35/13-06JJ 29 PRIMROSE ST  
Chevy Chase Village Historic District

**Katz  
Renovation**

SUBJECT: Historic Area Work Permit #439902, dormer enlargement

<b>Address:</b>	29 Primrose Street, Chevy Chase	<b>Meeting Date:</b>	12/20/2006
<b>Resource:</b>	Contributing Resource Chevy Chase Village Historic District	<b>Report Date:</b>	12/13/2006
<b>Applicant:</b>	Ruth Katz (Anne Decker, Architect)	<b>Public Notice:</b>	12/06/2006
<b>Review:</b>	HAWP	<b>Tax Credit:</b>	None
<b>Case Number:</b>	35/13-06JJ	<b>Staff:</b>	Anne Fothergill
<b>PROPOSAL:</b>	Dormer enlargement		
<b>RECOMMENDATION:</b>	Approve

3rd Floor Plan - Proposed

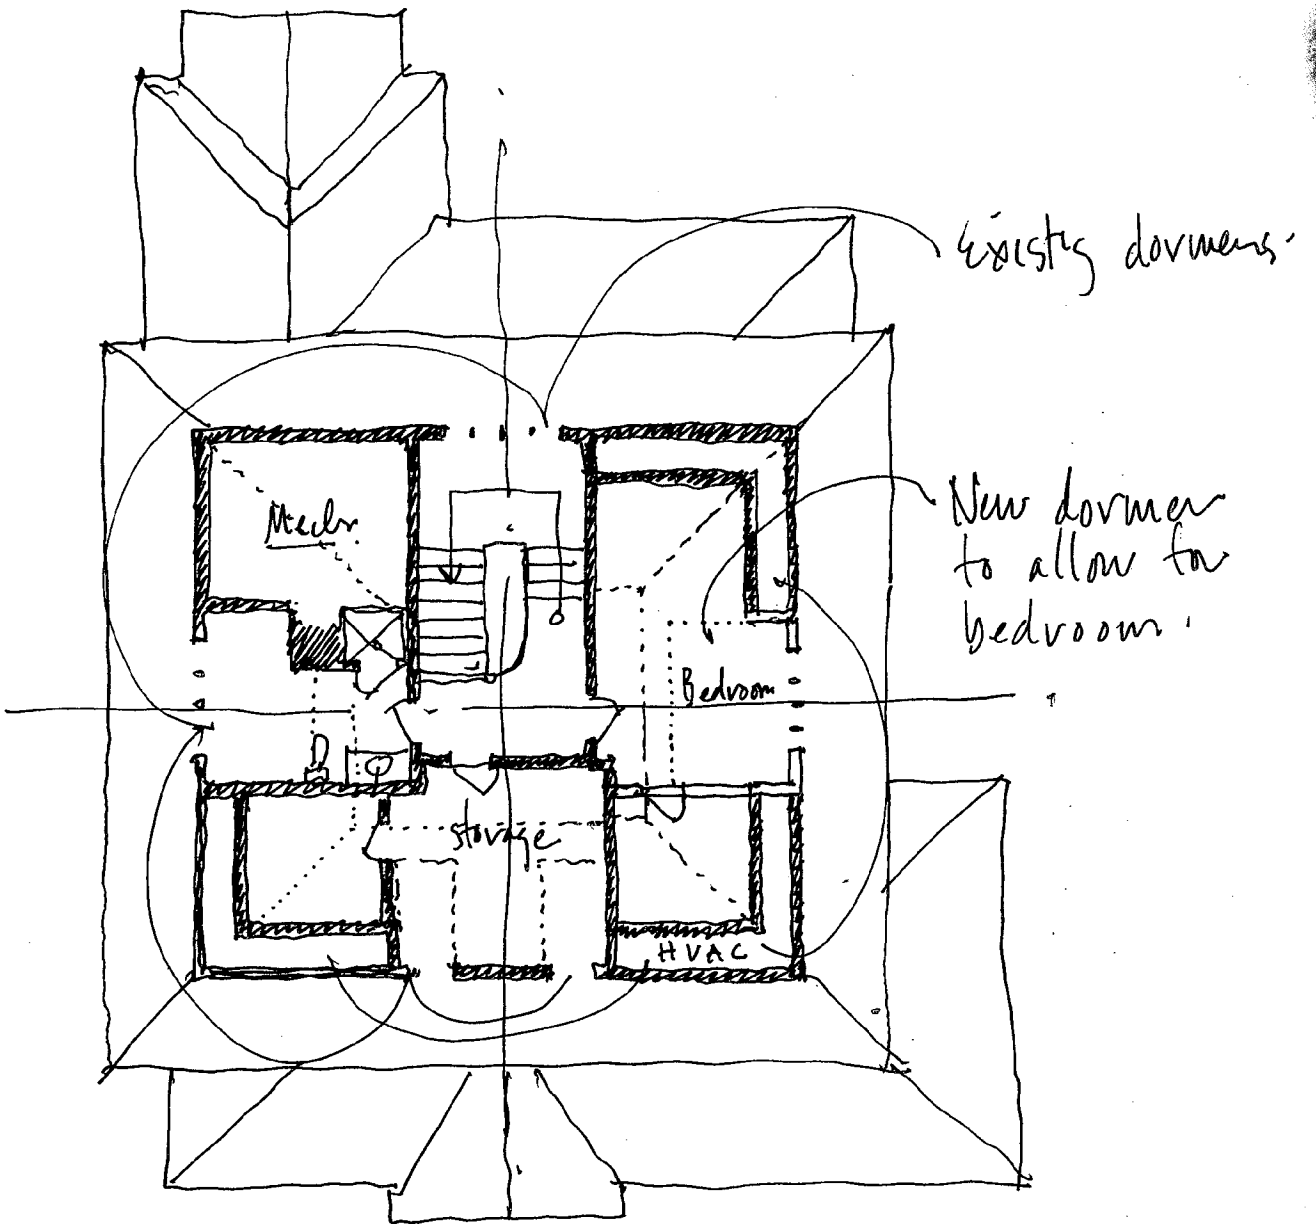
New dormer to allow for bedroom.

East Elevation

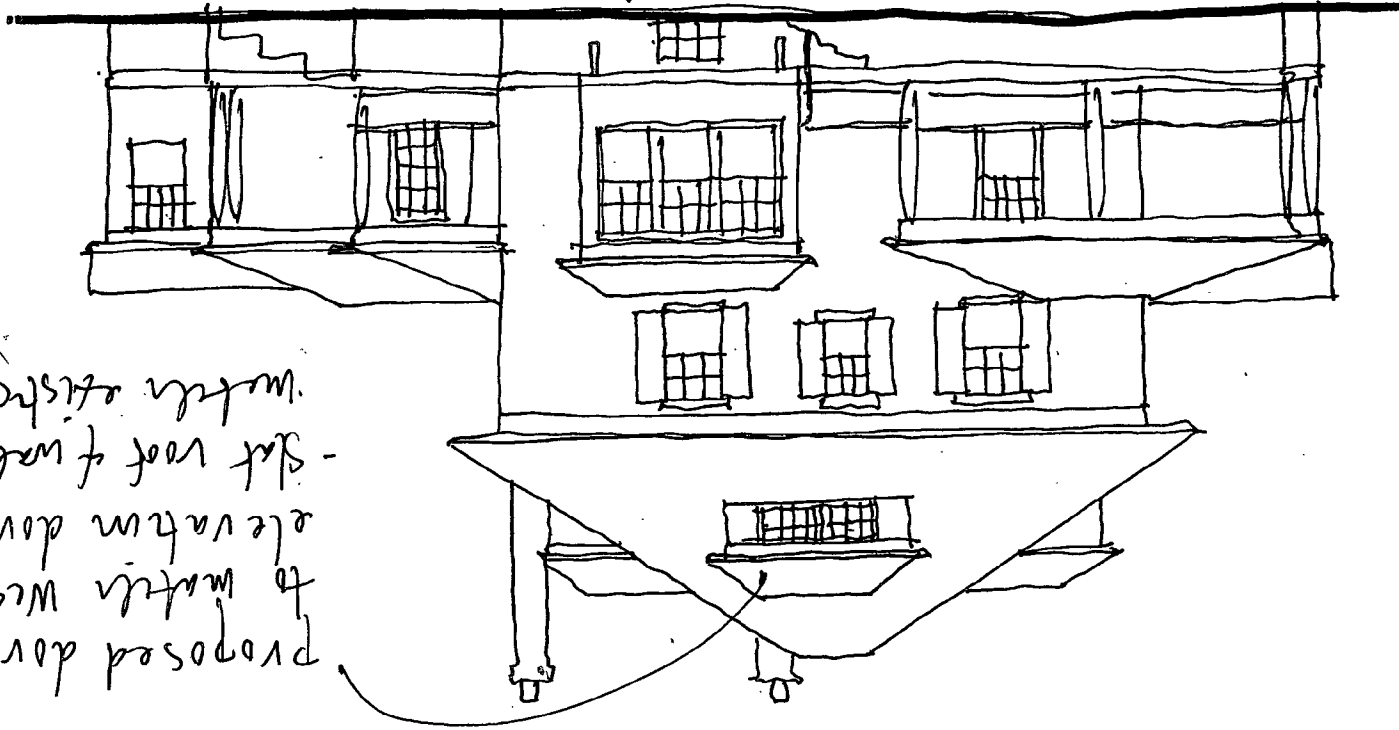
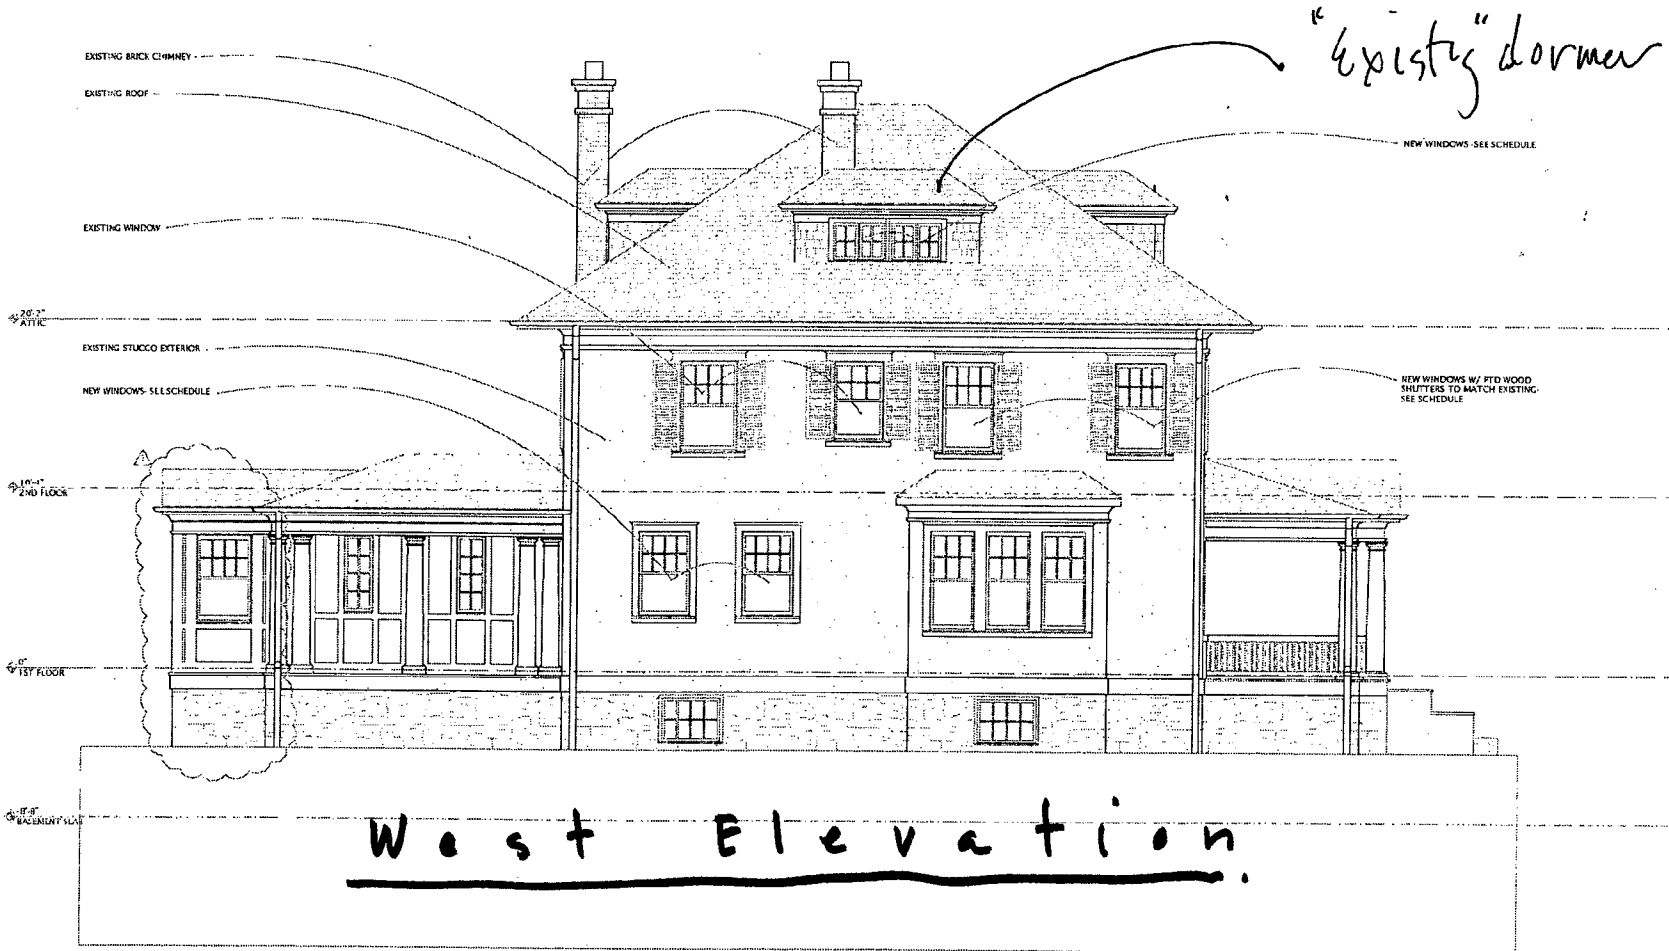
Proposed dormer  
to match west  
elevation dormer  
- flat roof of walls to  
match existing.

FIRST FLOOR PLAN

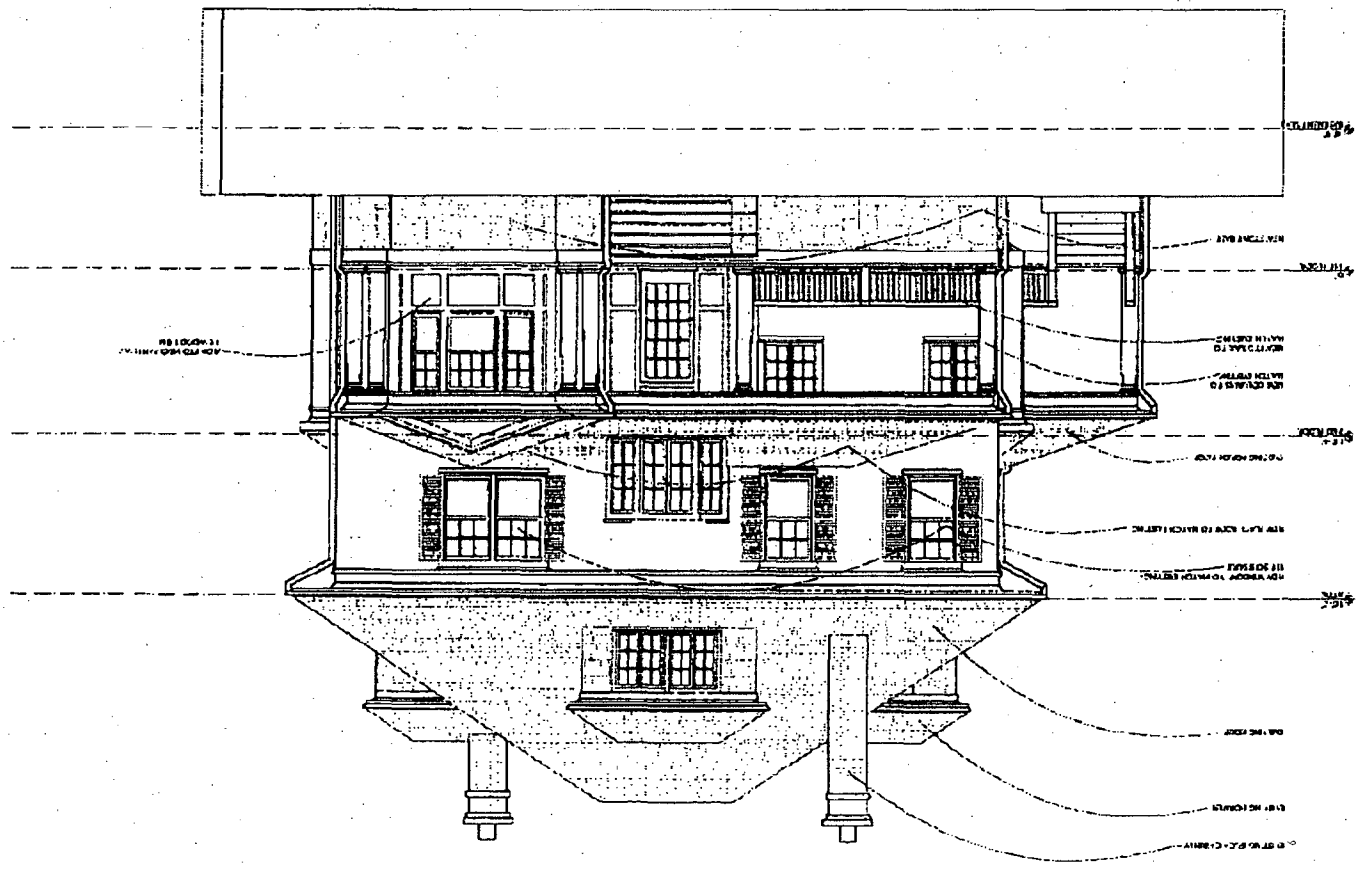
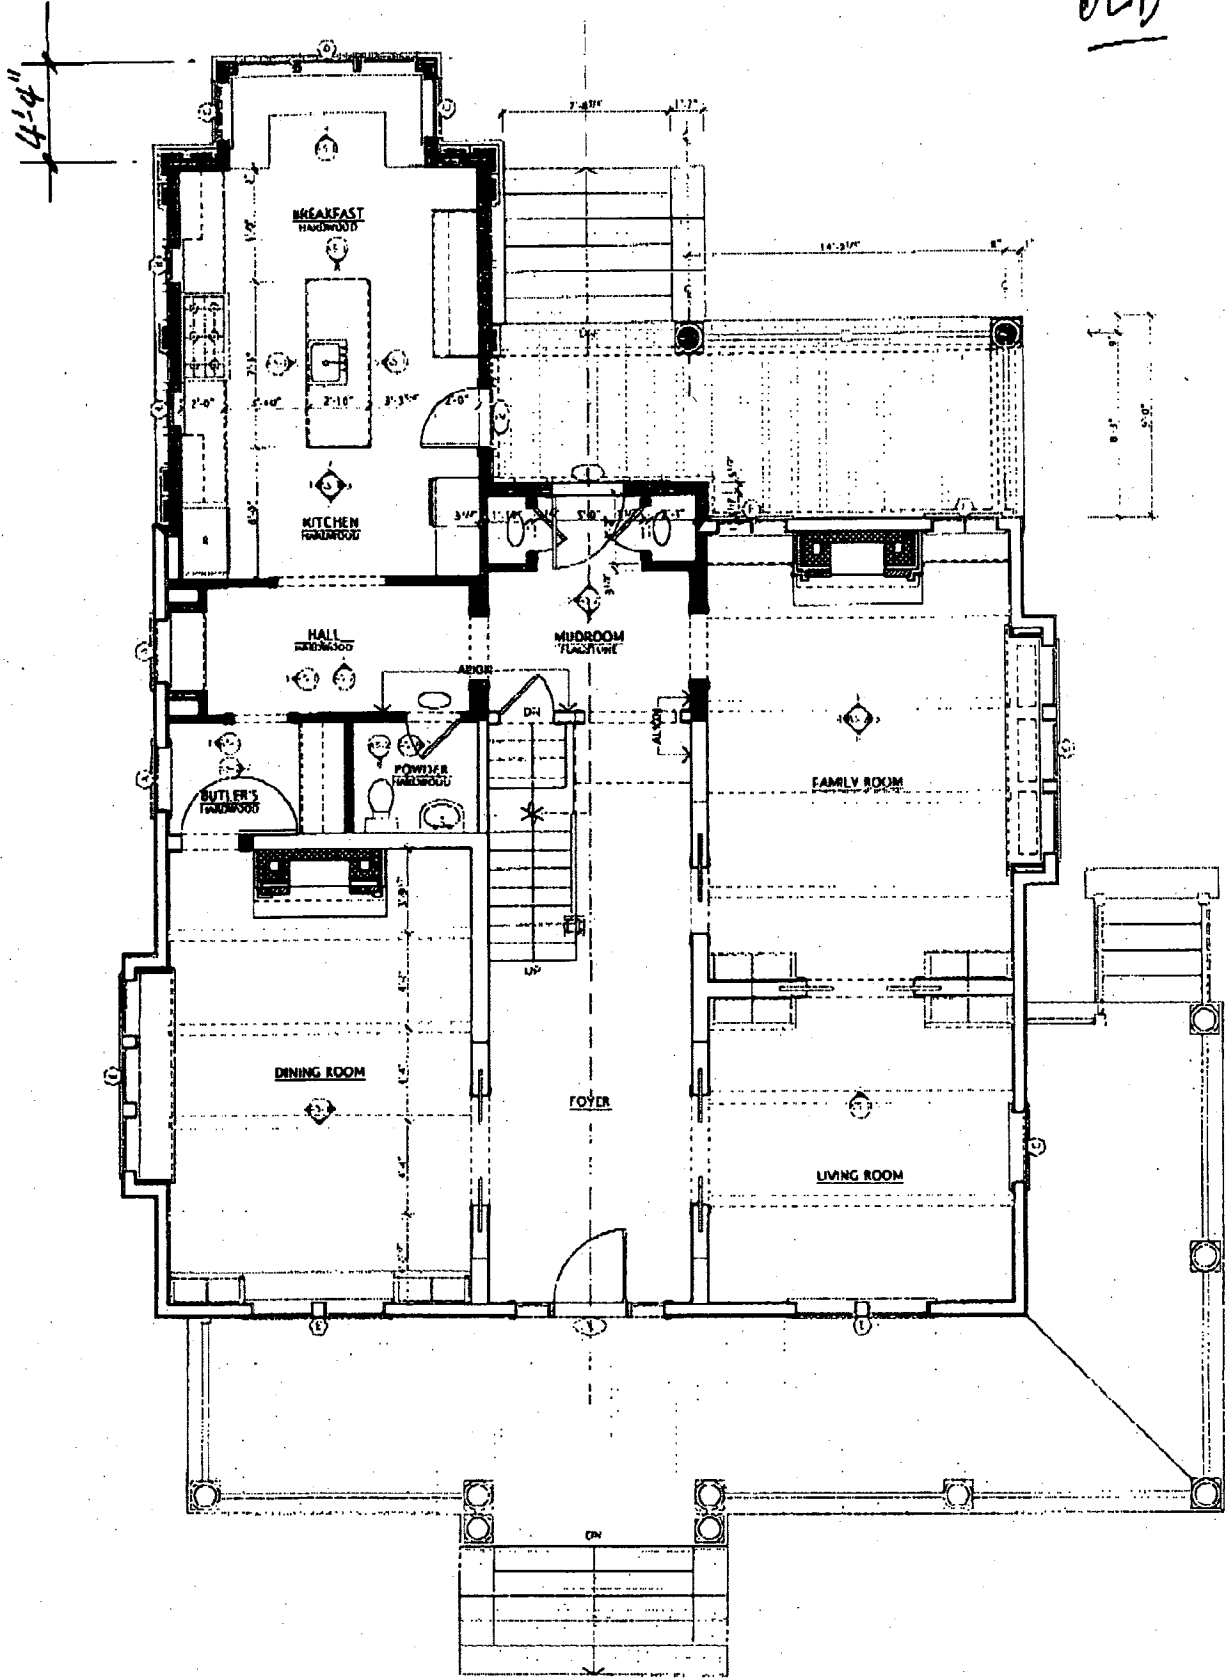
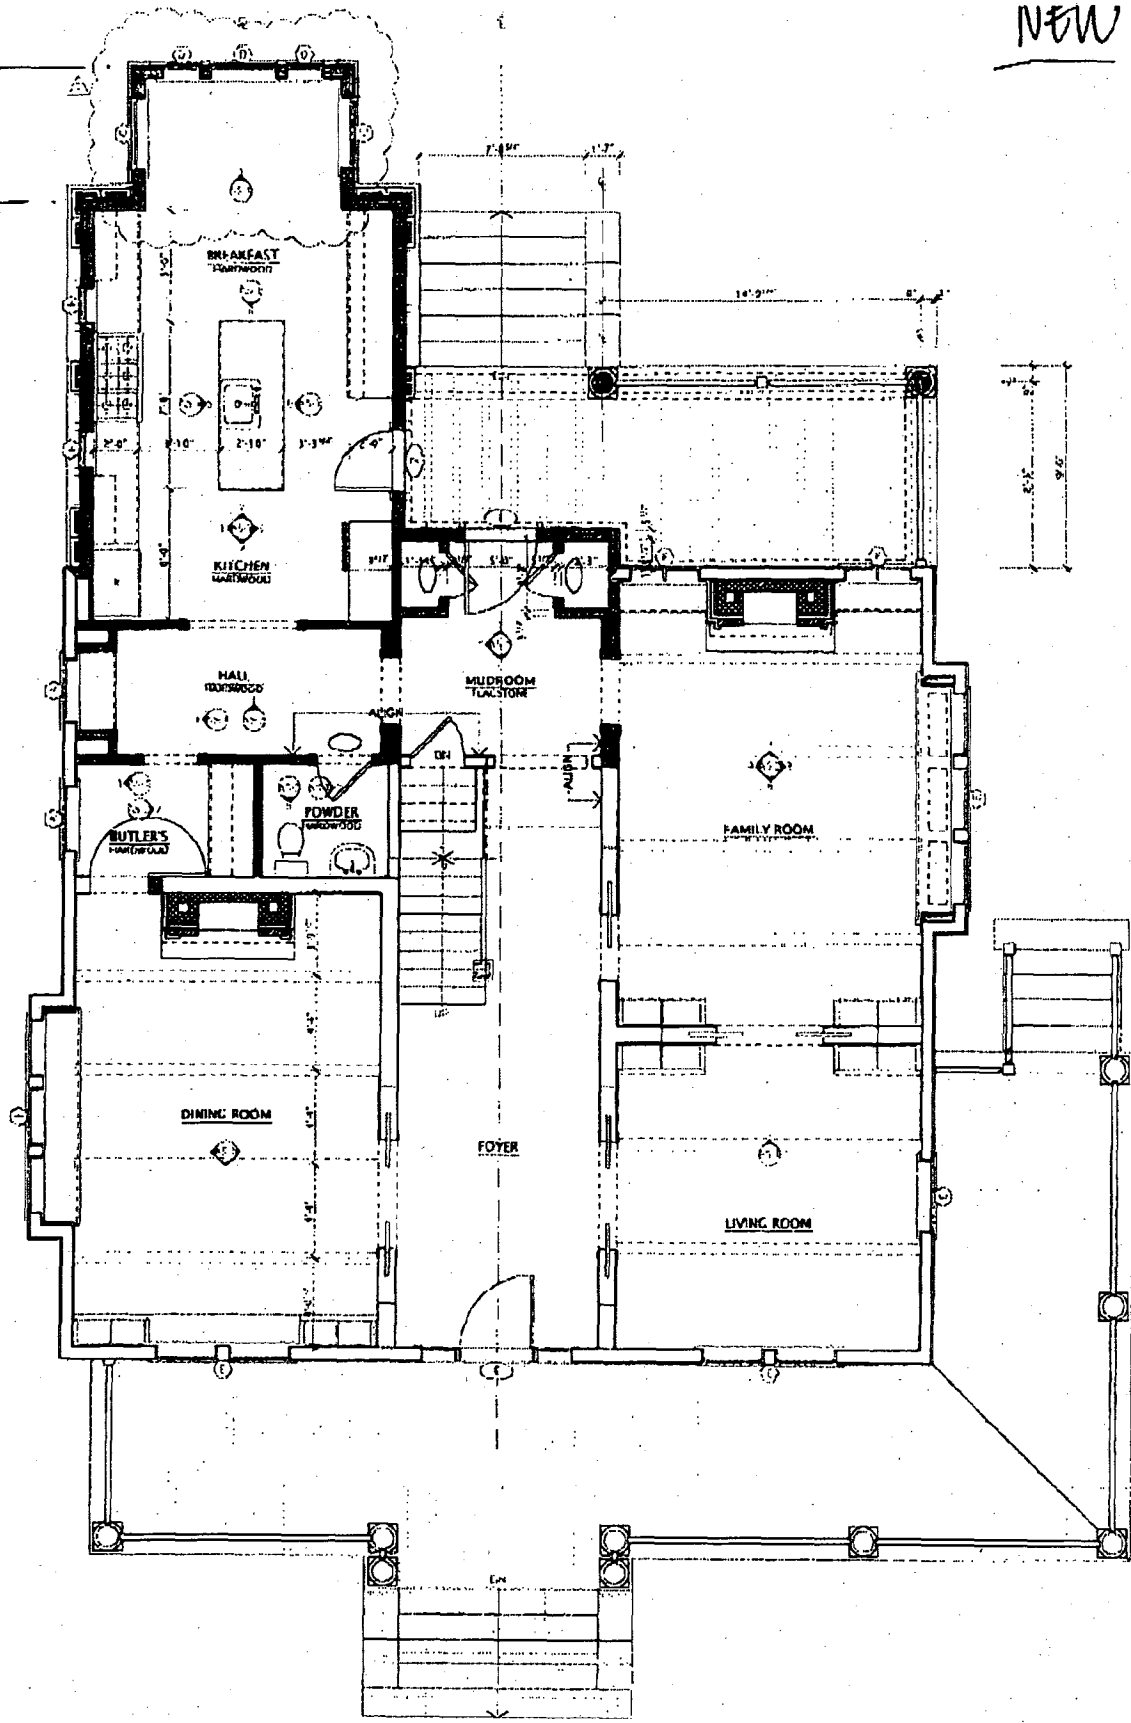
The applicants are proposing to extend the rear bay on the new addition by an additional 1' 6". The approved and proposed plans are marked "old" and "new" in Circles 2-9. Staff is requesting that this minor change be approved at the staff level.
